Access Compliance Report

Public Rights-of-Way

Intersection ID: 11980	Main Street: ALLEN_ST	Cross Street: E_17TH_ST	Location: S
ADA ID: 27EC2DAEB49E	Ramp Type: PerpDiag	Initial Pass/Fail: Fail	Overall Compliance: No
		Severity Score: 12.5

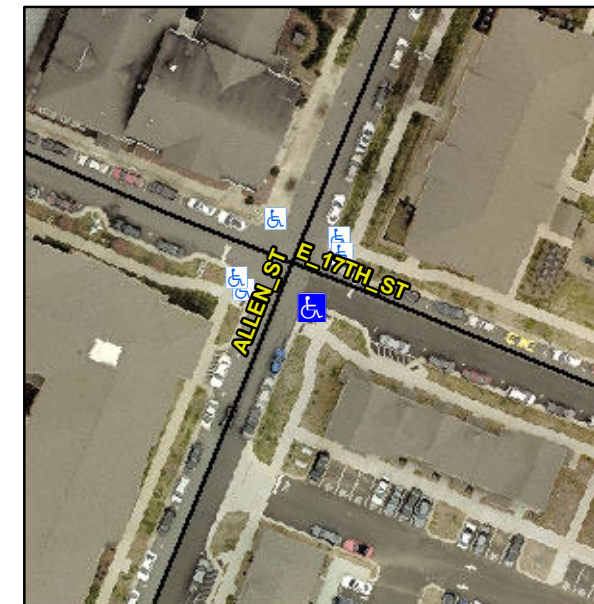
Compliance	Description	Data	Compliance	Description	Data
N/A	Ramp Length (in)	50.0	No	Ramp Slope (%)	8.4
Yes	Ramp Width (in)	67.0	Yes	Ramp XSlope (%)	1.4
N/A	Flare Type LT	N/A	N/A	Flare Type RT	N/A
N/A	Flare Slope LT (%)	N/A	N/A	Flare Slope RT (%)	N/A
N/A	Flare Traversable LT?	N/A	N/A	Flare Traversable RT?	N/A
N/A	Landing Length (in)	N/A	N/A	DWS Provided?	N/A
N/A	Landing Width (in)	N/A	N/A	DWS Contrast?	N/A
N/A	Landing Slope (%)	N/A	N/A	DWS Length (in)	N/A
N/A	Landing X Slope (%)	N/A	N/A	DWS Full Width?	N/A
N/A	Landing Curb? (Y/N)	N/A	N/A	DWS Offset (in)	N/A
N/A	Shared Landing?	N/A			
N/A	Gutter Ponding?	N/A	N/A	Gutter Slope (%)	N/A
N/A	Gutter Lip Ht (in)	N/A	N/A	Gutter X Slope (%)	N/A
N/A	Painted X Walk1?	No	N/A	Painted X Walk2?	No
	X Walk 1 Direction	To NE		X Walk 2 Direction	To NW
N/A	X Walk 1 Width (in)	N/A	N/A	X Walk 2 Width (in)	N/A
	X Walk 1 Slope (%)	2.6		X Walk 2 Slope (%)	2.4
	X Walk 1 X Slope (%)	2.7		X Walk 2 X Slope (%)	0.3

Remove & Replace Curb Ramp With Two New Directional Ramps or Equivalent.
